**FIELDS PARK/ CENTENNIAL MILL
PEDESTRIAN BRIDGE**

SCHEMATIC DESIGN

ETH C.3 (14 pgs.) Copy
Drawings for 1.21.10 DAR
09-170059

STUDY MODEL IMAGES

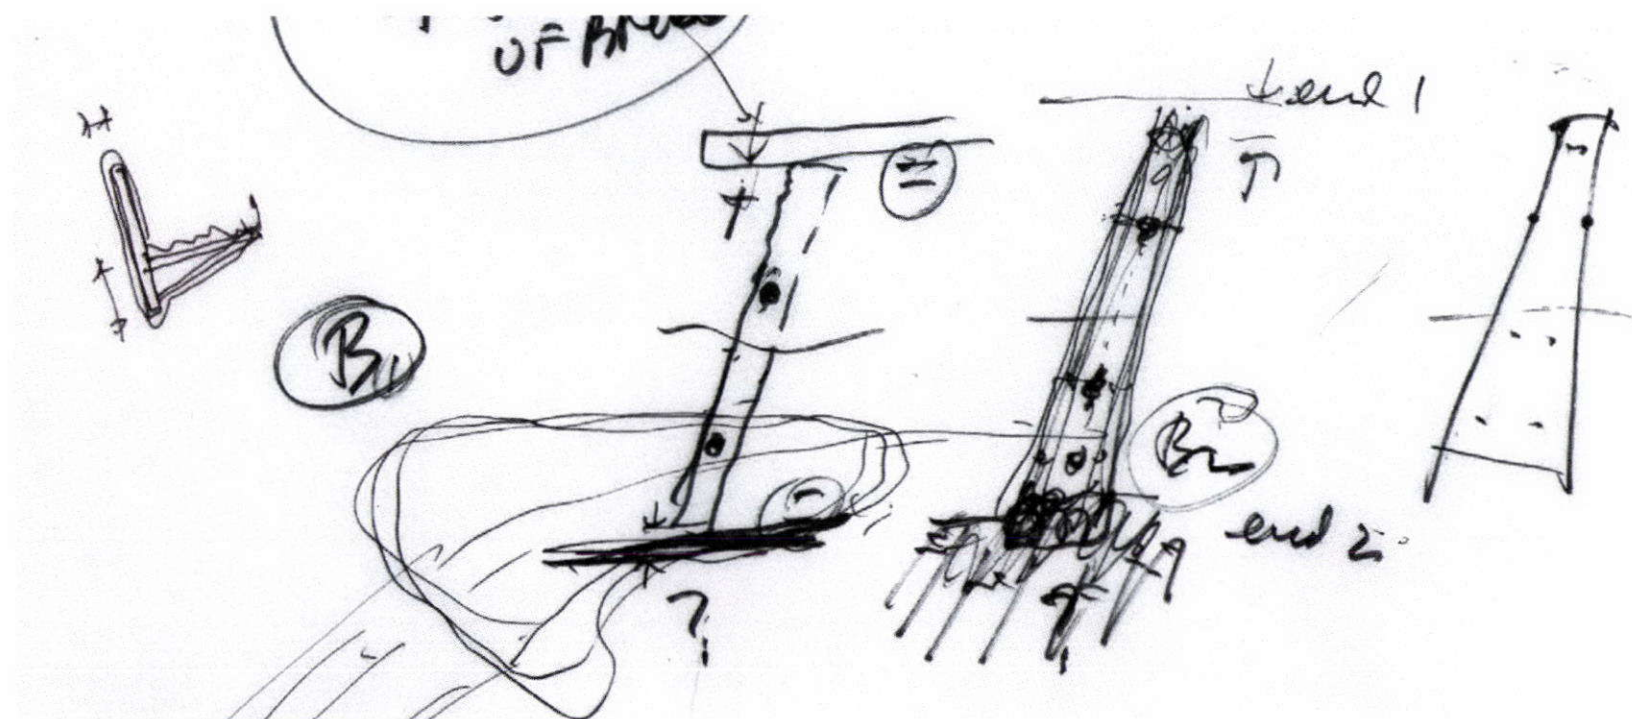
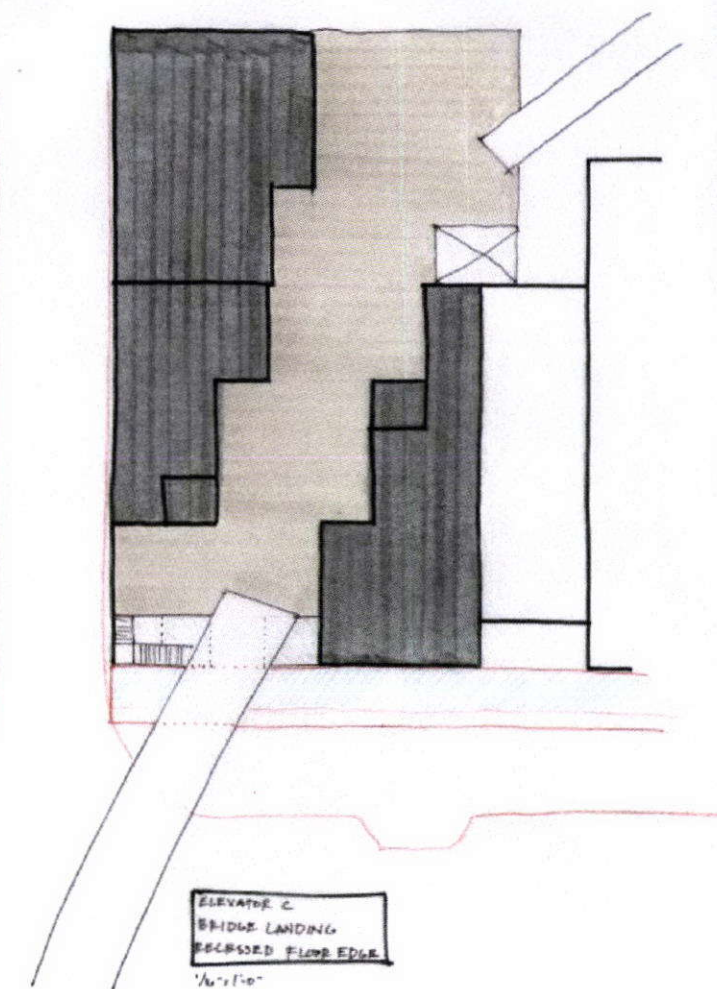
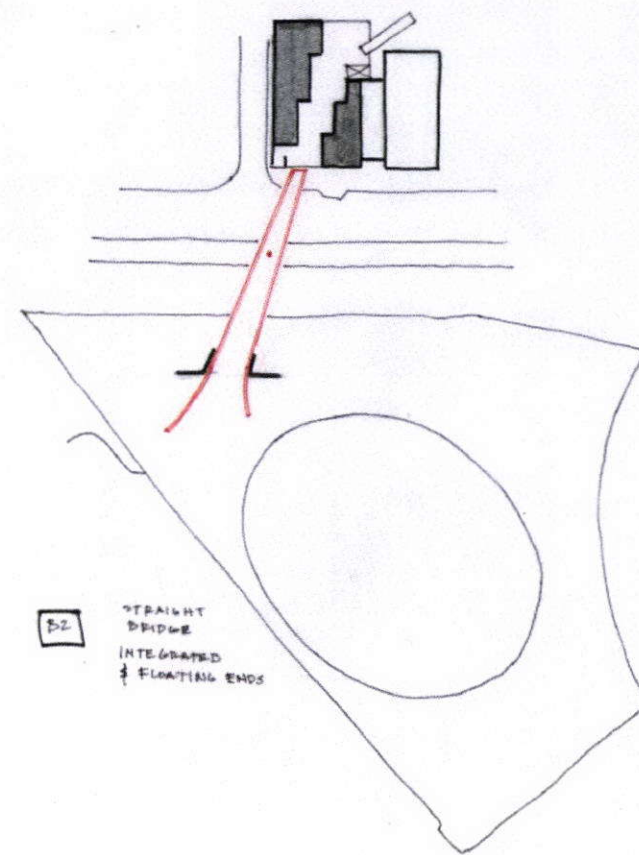
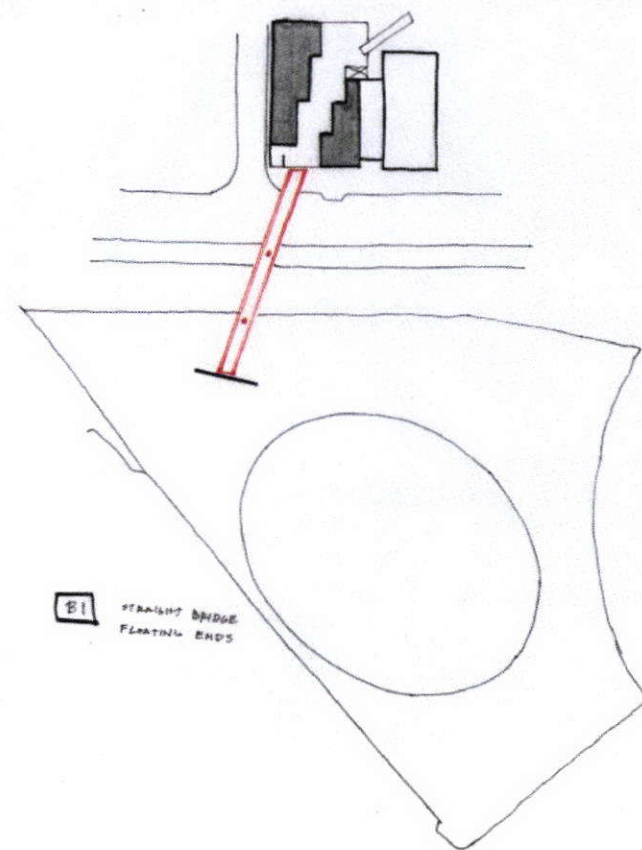
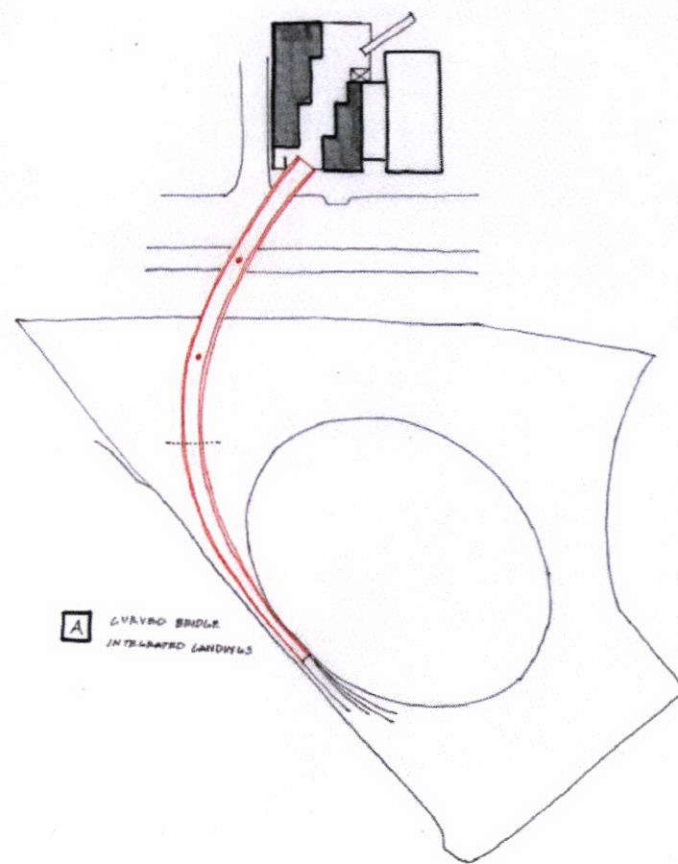
A BOX BEAM
BOTH SIDES - BY
BEING SQUARE, CAN
SIDE BOX
PARTS BE
SWAPPED?

B TUBED TUBES
AT SHOWN WOULD HAVE
COLUMNS @ 2' DIA. A.
WENT VARIATIONS IN
NUMBER IS POSSIBLE
TO "PUSH UP" A
MORE CONVENTIONAL
SOLUTION?

C HEAVY STEEL
PLATE GIRD W/IN/BEAMS.
COULD WE LOWER CUT
THESE STEEL PLATES TO
MAKE A CONTINUOUS
MEMBER BUT ALLOW
OPENINGS? HOW
PROFESSIONAL COULD IT
BE? WHAT FOR CENTRAL
@ C. STEEL IS PROPOSED?
